Campbell River Environmental Committee (CREC)
PO Box 20092 STN. A, Campbell River, B.C. V9W 7Z5

Re: CREC Comments on Operational Certificate #107689 at 7295 Gold River Highway, Campbell River

After reading all the reports commissioned to study this application for Upland Excavating Ltd. (Upland), the Campbell River Environmental Committee (CREC) feels the reports collectively raise the following issues:

Figure 7: View of pit from the south, ponding in foreground at the location of proposed landfill

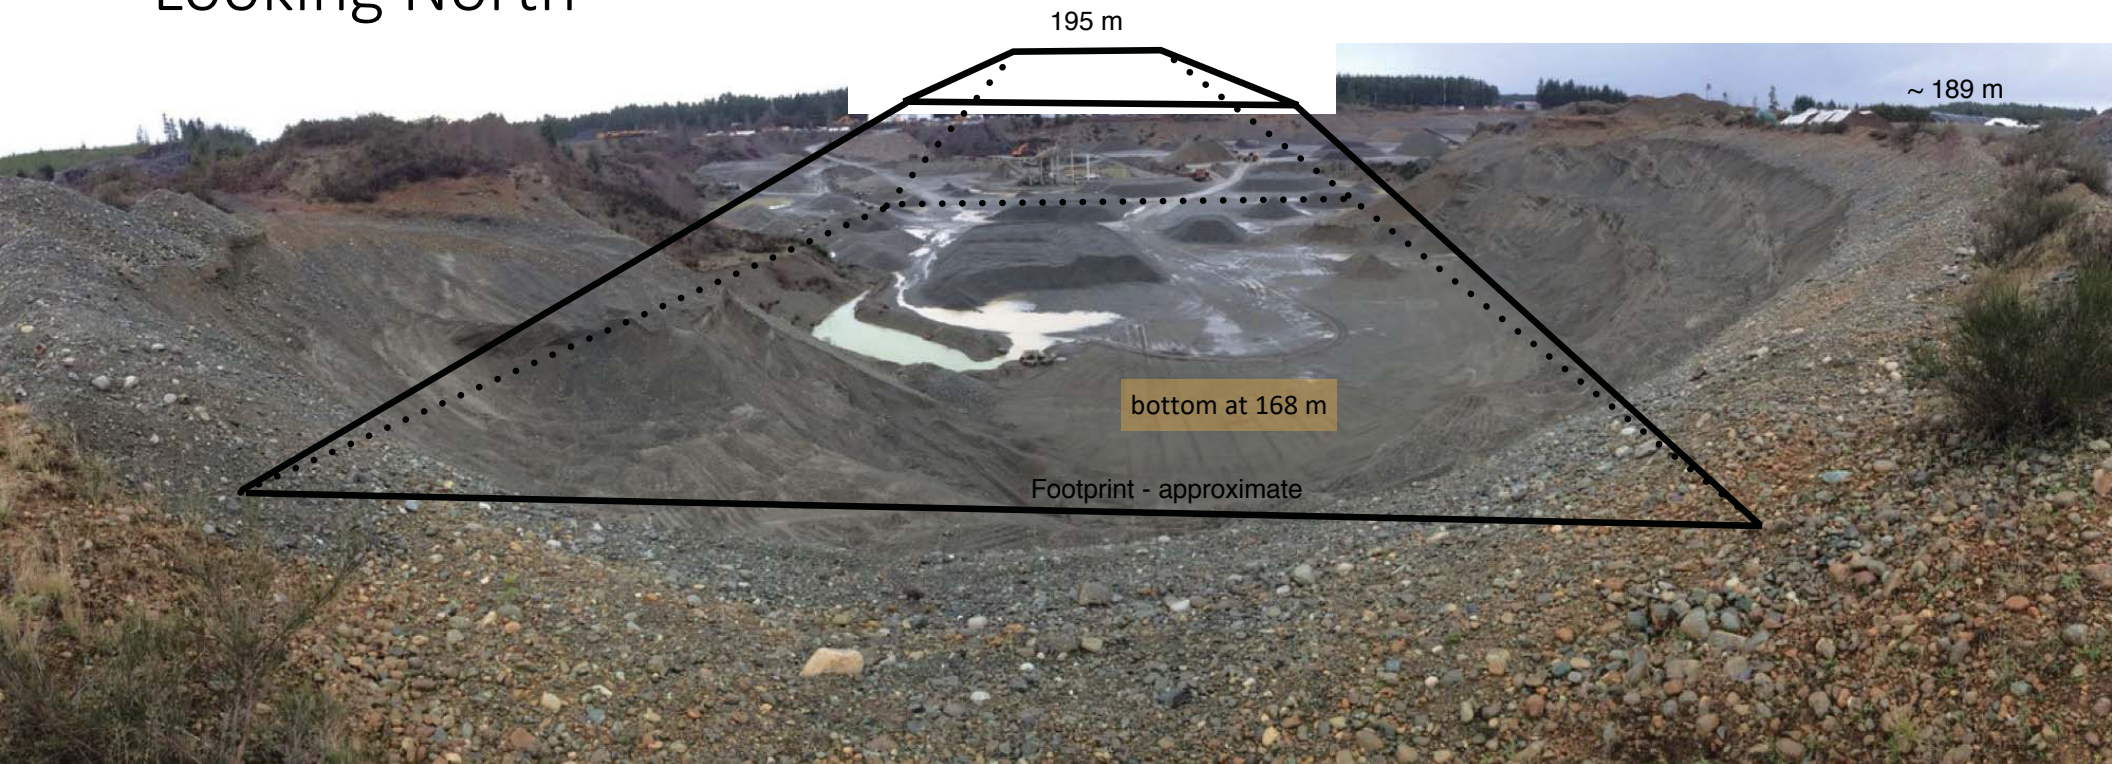
“During Waterline’s January 22, 2019 site visit, significant ponding was noted in the base of the pit (Figure 7). The Upland staff indicated that the pond remains for most of the winter but the area is consistently dry in the summer (Terry Stuart and Mark Stuart pers. comm.). **The cause of ponding in the pit needs to be further investigated as it appears to contradict GHD’s interpretation of high infiltration capacity.** (emphasis added) The layered structure of the sand and gravel aquifer visible in the south pit wall, should have prompted in-situ testing to determine the site-specific infiltration capacity even for the preliminary landfill design.” Source: Waterline Hydrogeological Review of the Proposed Upland Landfill, February 25, 2019 section 2.4

“According to GHD, the sand and gravel is thick under the pit (Figure 4), and its hydraulic conductivity 2 x 10⁻² cm/s (Technical Response to ENV Review (Auth. No.:Pr-10807) Task 8). **With such a high hydraulic conductivity, water should not be ponding, and surface water is expected to infiltrate very rapidly through the pit floor.**”

Given Terry and Mark Stuart stated that the ponding remains for most of the winter, has MOE investigated this ponding?

Is the MOE satisfied that the groundwater level will not be less, during the winter, than the 1.5m below the bottom of the proposed landfill required in the Env. Landfill Criteria?
